CHANGE ORDER NUMBER: 6

Project:	<u>1604-068</u>
Roadway:	<u>Forest North Drainage Ph 1</u>
CSJ Number:

**Forest North Phase 1
Williamson County Project No. 1604-068**

Change Order No. 6

R-1879 Series Frame, Solid Lid/Grate

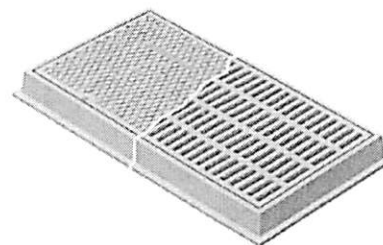
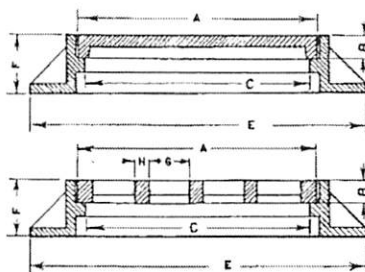
Note: The Lump Sum cost for Item 999-WC06 includes the cost of removal and haul off of 4 safety end treatments, installation of 3 – (18" x 24") inlet grates, concrete collars between new pipe and existing pipe, the additional cost for the Class IV pipe compared to the Class III pipe, and the removal / replacement of Driveway 12.

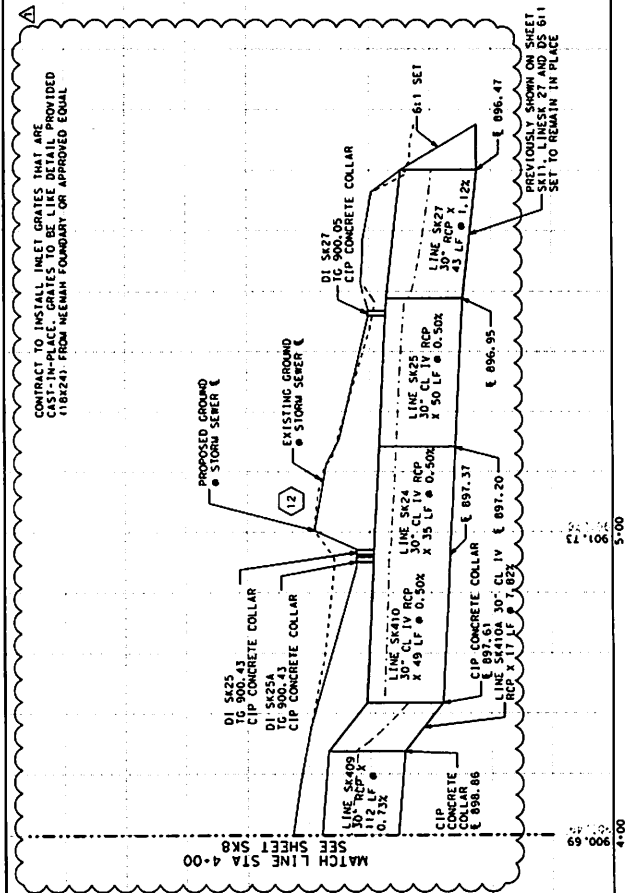
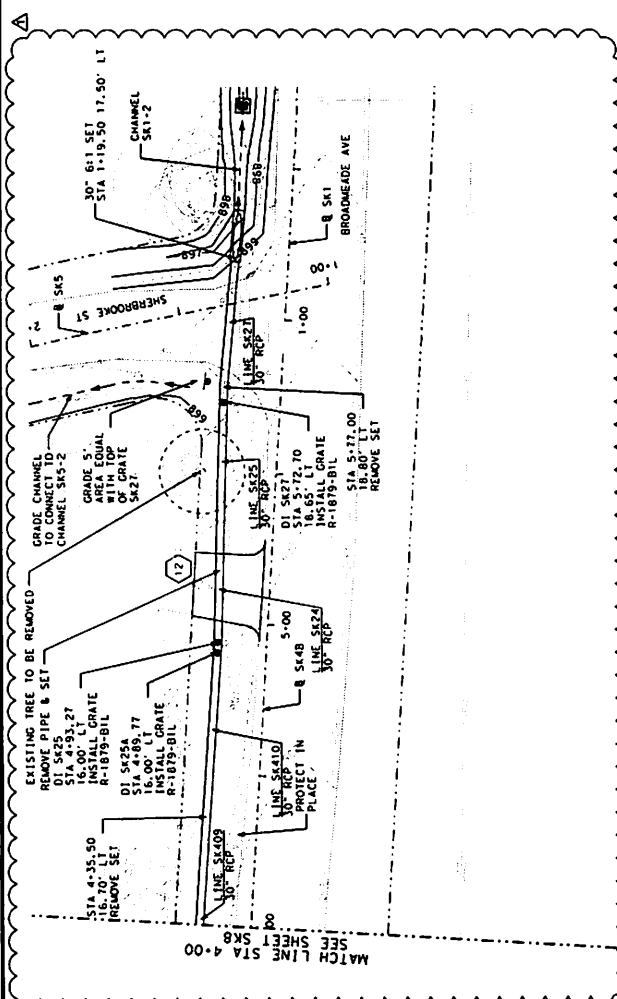
3F: County Convenience. Additional work desired by the County. This Change Order revises drainage work at the corner of Broadmeade and Sherbrooke Street in the Sherbrooke Zone. After review, the County requested that the open ditch design be changed to an underground pipe system due to the depth of the ditches.

The County has requested that the ditches on either side of Driveway 12 at the corner of Broadmeade Avenue and Sherbrooke Street be enclosed with an underground drainage system. Please provide a design for this underground system.

The proposed solution requires Driveway 12 to be removed and replaced and three additional grates. The plans and grate cut sheet are attached.

CONTRACT TO INSTALL INLET GRATES THAT ARE FAST-IN-PLACE. GRATES TO BE LIKE DETAIL PROVIDED (18X24), FROM MEEHAN FOUNDARY OR APPROVED EQUAL.
